Issued date: 2010/11/17

iEi Products Change Notice

Display Monitor Models: AUPS series

AUPS-A10-R10 / AUPS-A20-R10

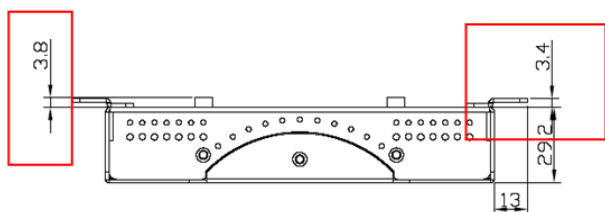
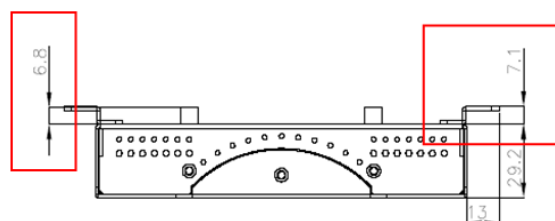
iEi will upgrade the AUPS series. Main reason is to upgrade the Mechanics Design to make the structure firmer. Please refer to attachment for detailed list of discontinued products and information on the replacement product.

| Phase-out Model | Replacement model suggestion | Phase-out Reason |
|-----------------|------------------------------|---|
| AUPS-A10-R10 | AUPS-A10-R11 | 1. Modify VESA screw hole from 3.4mm to 6.8mm 2. Modify Wall Mount Kit from 3.4mm to 7.1mm |

AUPS-A10-R11 / AUPS-A20-R11
